Appendix A:  
Compiled Comment Letters

RE: 3003 Runyon Canyon – Draft Environmental  
Impact Report (DEIR)  
SCH # 2018041016  
GTS # 07-LA-2018-02783  
Vic. LA-101/PM: 8.784

**SUBJECT: 3003 RUNYON CANYON - NOTICE OF COMPLETION AND AVAILABILITY OF DRAFT ENVIRONMENTAL IMPACT REPORT**

**Figure 1 – Google Earth Measurement Width of Roadway Along Edge of Project Parcel**

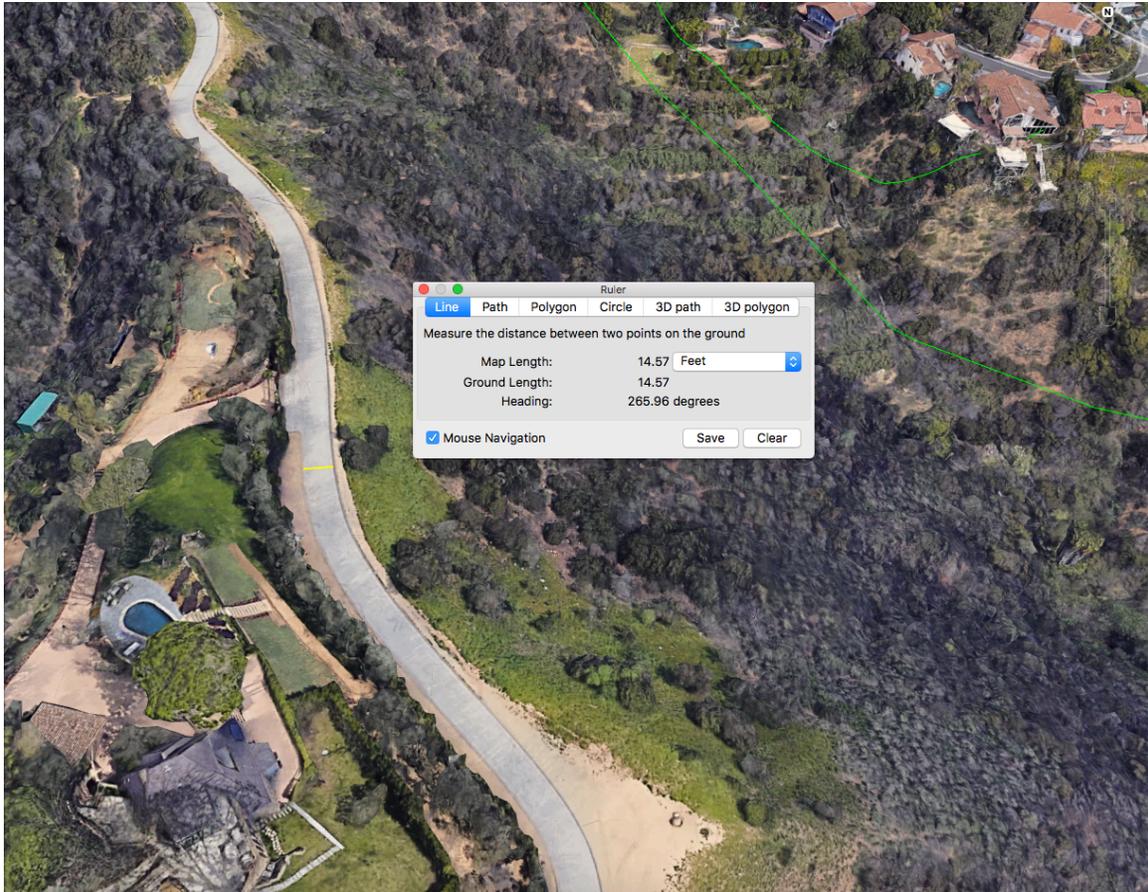
North Runyon Road is not a public street. The DEIR fails to identify the approvals required to allow new development on a parcel that does not abut a public street. The project description needs to describe any required improvements to North Runyon Road included as part of the proposed project; no such improvements are specified in the project description or included as mitigation measures. The project description or the existing setting needs to provide information on the existing roadway width of North Runyon Road and whether it meets applicable street access requirements in the Municipal Code, such as Section 12.21 C.10(i). Based on measurements taken using Google Earth, shown in **Figure 1**, it does not appear that North Runyon Road meets the requirements for a Standard Hillside Limited Street and would thus be considered a Substandard Hillside Limited Street. Failure to comply with Hillside Ordinance requirements regarding obligations for projects on a Substandard Hillside Limited Street should be identified as a significant land use impact in the DEIR.

**Figure 3 – Location of Pool To Be Removed, Retaining Wall #3 and Fill-Sites (DEIR Figure II-1 Detail) In Relation to Historic Residence**

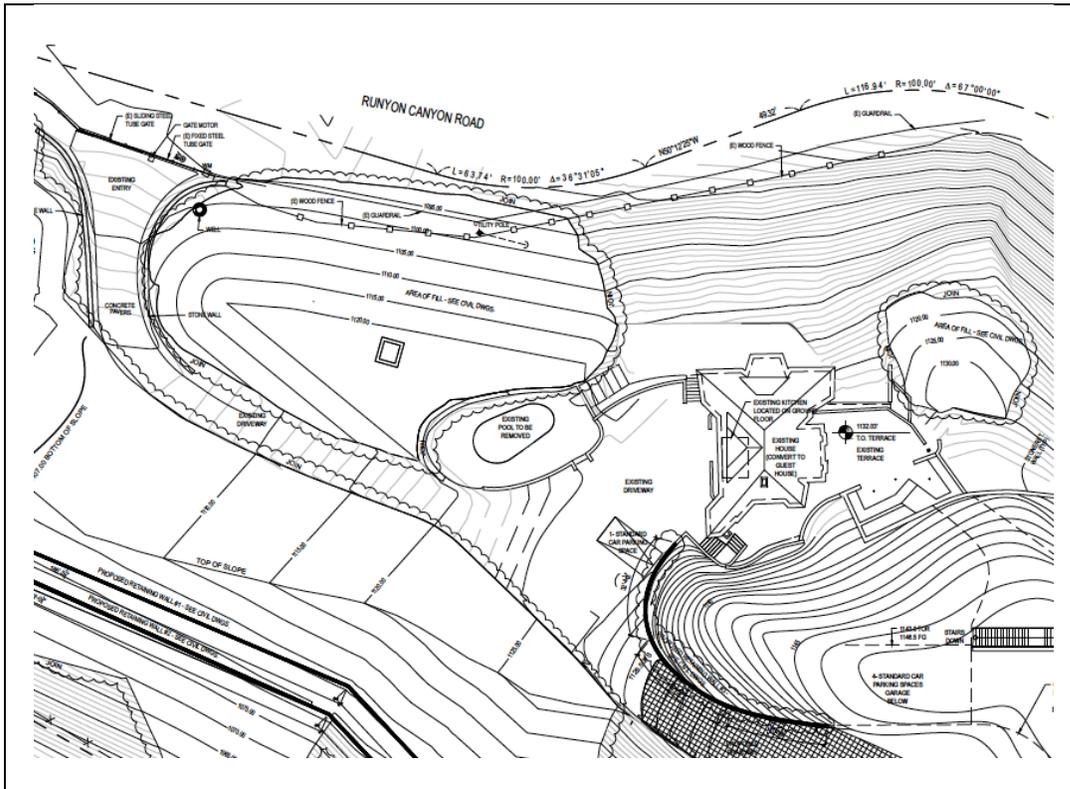
However, the analysis fails to address the third retaining wall, which is located in close proximity to the historic residence (see Figure II-1 and Figure 13 in Appendix F-1). More information and analysis of the potential impacts of retaining wall #3 on the setting of the historic resource is required before it can be concluded that impacts are less than significant.

The cultural resources analysis fails to address the potential impact of the fill sites proposed to be located on the hillside just north and east of the historic residence as shown on DEIR Figure II-1. (See **Figure 3** for a comparison of details from Figure II-1 and the Google earth view of the project site). The cultural resources analysis, in concluding consistency with the *Secretary’s Standards*, relies on the inaccurate statement that “there will be no changes to the immediate setting of the historic residence” (see page 16 Appendix F-1). Not only will the fill sites alter the topography, but also one of

the fill sites will result in the loss of the stairway from the pool through what will become the fill site.
